Product Change Notification

1. ECR #: 25-38569-1
Notification #: 803

- BCS-1XX-XXX-D-HE-XXX - null
- SSM-1XX-XXX-DH-XX-XX-XX-X-XX - null

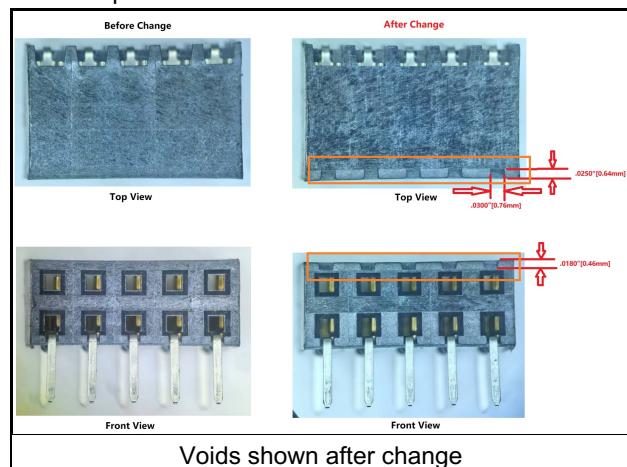
Add voids across the top front area of body, void size is about 0.76 x 0.64 x 0.46 mm.

Add voids (about 0.76 x 0.64 x 0.46 mm) to improve resin reflow and body manufacturing stability, no functional concern. This will be a rolling change.

- Form - This will be an appearance difference.
